SITE PLAN REVIEW AND APPEARANCE BOARD STAFF REPORT

SW 3rd Avenue Townhomes

Meeting	File No.	Application Type
August 26, 2026	2024-170	Level 2 Site Plan with Landscape Waiver
Property Owner	Authorized Agent	
VF Realty OZ Business, LLC	Mike Coveilli, Covelli Design Associates, Inc.

Consideration of a Level 2 Site Plan application to construct five, two-story fee-simple townhomes, including Architectural Elevations, a Landscape Plan, and an associated waiver from the required street tree location and a reduction in the number of required street trees along SW 3rd Avenue.

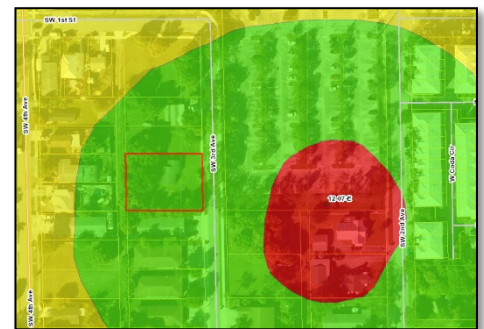
The proposed development generally complies with the applicable performance standards by providing a functional site layout that accommodates residential use, required parking, stormwater management, and open space while maintaining compatibility with surrounding properties. The scale of the proposed five fee-simple townhome development aligns with the Southwest Neighborhood;

however, the site presents unique constraints that influence the overall site design, including the property's location within the Wellfield Protection Zone 2 and the existing unimproved condition of the rear alley. Due to ERM restrictions prohibiting new exfiltration systems, the applicant is required to incorporate a dry retention area at the rear of the property, which limits opportunities for alternative building placement and alley-oriented access configuration. Additionally, while utilizing the rear alley could reduce driveway conflicts along SW 3rd Avenue and improve pedestrian-oriented circulation, the existing unimproved condition of the alley restricts its functionality as a primary access point.

As a result, the project proposes individual driveway access along SW 3rd Avenue, which is not the preferred urban design outcome but remains functional for the scale of the development and does not create an adverse impact on neighborhood circulation or safety. Overall, the proposed site plan demonstrates compliance with site plan standards by providing a safe and functional development pattern that responds to the site's environmental and infrastructure constraints while advancing compatible infill redevelopment within the Southwest Neighborhood.

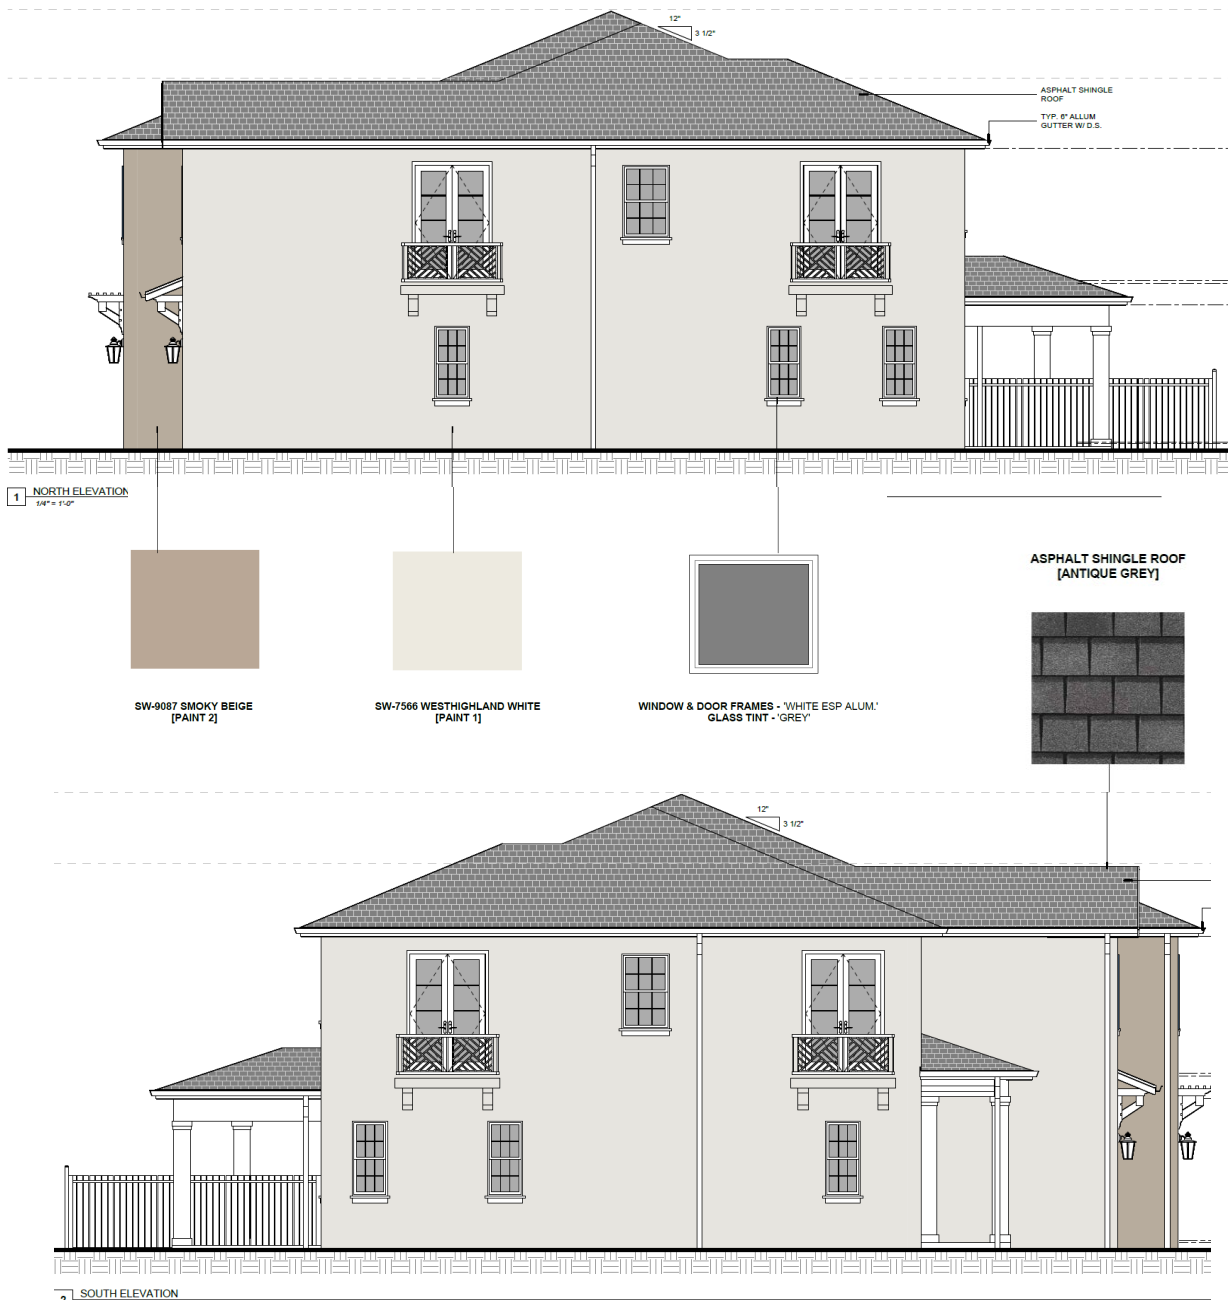
The proposed development complies with the architectural and aesthetic requirements by establishing a unified architectural character among the five townhome buildings through the consistent use of complementary architectural elements, materials, colors, and building forms. The proposed two-story fee-simple townhomes utilize a warm, neutral color palette with blue accent elements and a consistent architectural expression, creating a cohesive appearance across the development. The use of CBS construction coordinated roof forms, windows, doors, garage treatments, and exterior finishes further contributes to a harmonious architectural composition. The scale and mass of the proposed buildings are consistent with the surrounding residential character and are appropriate for the infill redevelopment of the site. The architectural design is also responsive to the established neighborhood context within the Southwest Neighborhood by providing residential-scale buildings rather than an intensive or incompatible development form. As a result, the proposed development creates a cohesive architectural character and enhances, rather than detracts from, the character and attractiveness of the surrounding area. Images of the proposed elevations are provided below.

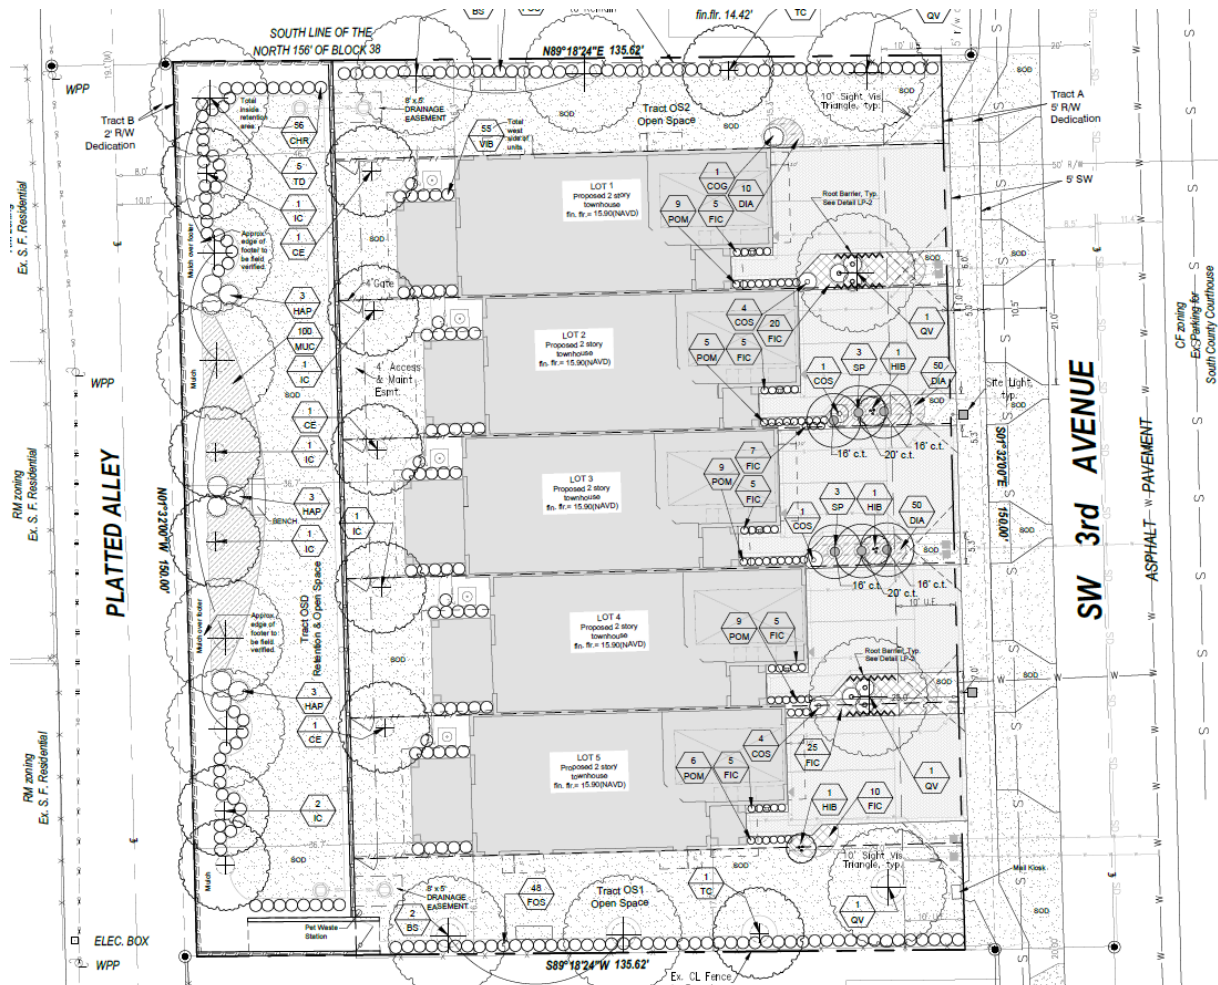
The proposed landscape plan provides a coordinated planting scheme for the five fee-simple townhomes and includes canopy trees, palms, shrubs, groundcovers, and foundation plantings. The plan provides landscape treatment along the front of each townhome, along the side and rear of the open space area, and around the drainage/open space tracts.

The plant palette includes native and Florida-friendly species such as Live Oak, Gumbo Limbo, Silver Buttonwood, Dahoon Holly, Tabebuia, Bald Cypress, Sabal Palm and various flowering and shrub materials. The landscape design also provides several positive site-design elements such as canopy trees incorporated throughout the development providing shade and visual relief from the two-story building, foundation and perimeter planting to soften the building edges and transitions between the buildings, driveways, and open-space areas. The proposed landscaping around the drainage and open spaces helps integrate the areas into the overall design rather than leaving them as purely functional stormwater facilities. The plan incorporates root barriers at certain locations, demonstrating consideration of conflicts between larger canopy trees with adjacent pavement and infrastructure. The use of different trees, palms, shrub, and groundcover species provides visual variety and layering at the pedestrian level.

Overall, the landscape design improves the existing condition by adding street trees, foundation planting, and perimeter landscaping. The proposed landscape improvements support the pedestrian frontage and provide unify the five individual fee-simple properties. The Board shall determine whether the landscape plan, together with the requested landscape waiver, is consistent with the applicable requirements and intent of LDR Section 4.6.16.

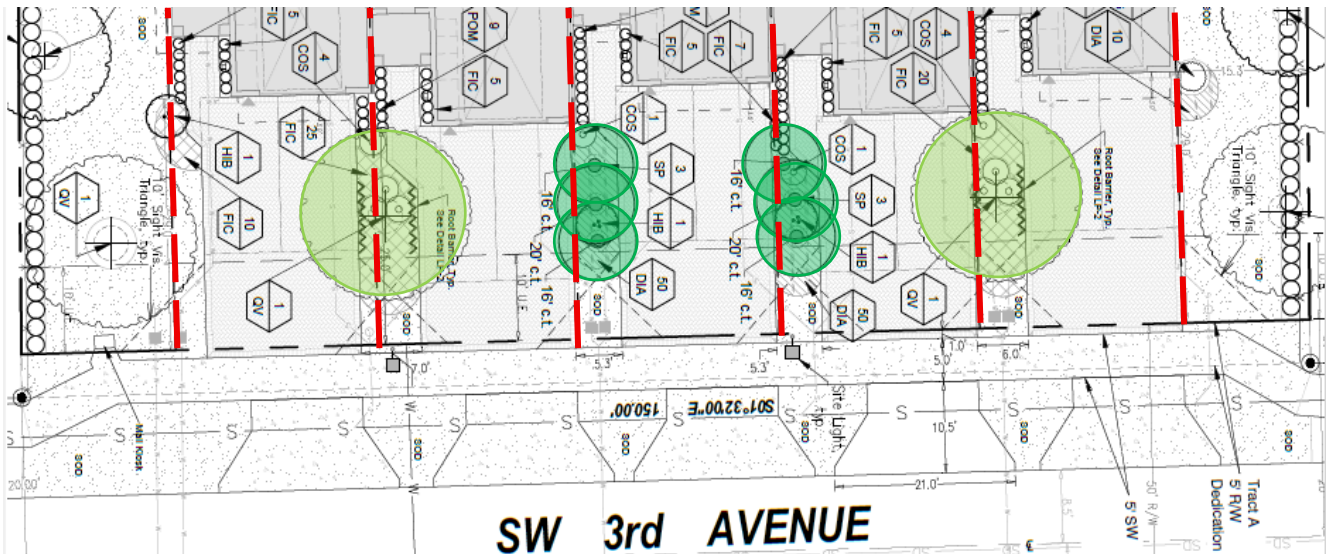
The proposed development is subject to the street tree requirements for new residential development pursuant to **LDR Section 4.6.16(H)(6)**, which requires one street tree for every 40 linear feet of street frontage, with a minimum of one tree per property. Street trees are required to be located between the inside edge of the sidewalk and the edge of road pavement. The proposed development consists of five individual fee-simple townhome lots; therefore, a minimum of five street trees is required. Although the approximately 150 linear feet of frontage would result in a calculation of four trees based on the 40-foot spacing requirement, the minimum of one tree per property establishes a requirement of five street trees.

The prescribed street tree planting area is constrained by an existing 8-inch sanitary sewer line. Pursuant to the applicable landscape standards, trees are required to maintain a minimum 10-foot separation from underground utility lines, or a minimum 4-foot separation when an approved root-ball barrier is provided. In addition, the five individual driveway connections, pedestrian sidewalk, sight visibility requirements, existing public infrastructure, and limited planting area within the right-of-way further constrain the ability to provide five street trees within the prescribed location. Therefore, the applicant is requesting a waiver from the required street tree location and a reduction in the number of required street trees.

Pursuant to **LDR Section 4.6.16(E)(3)(6)(b)**, three palms grouped together are considered equivalent to one shade tree. The proposed landscape plan provides two Live Oak canopy trees and two groupings of three palms along the SW 3rd Avenue frontage. Due to the location of the existing sanitary sewer line, the proposed canopy trees are limited to areas within the individual fee-simple lots between the driveway connections. The proposed landscape design therefore incorporates two shade trees and two groupings of three palms, which are equivalent to a total of four shade trees under the applicable landscape provisions.

While the proposed landscaping does not fully satisfy the required five street trees or the prescribed location within the right-of-way, the proposed design provides substantial canopy coverage, landscaping, and visual enhancement along the SW 3rd Avenue frontage. The proposed Live Oak trees will provide long-term canopy and shade, while the grouped palms provide additional vertical landscaping and visual definition along the street frontage. The placement of the landscaping within the individual lots also avoids conflicts with the existing sanitary sewer infrastructure while maintaining pedestrian and vehicular circulation and required sight visibility.
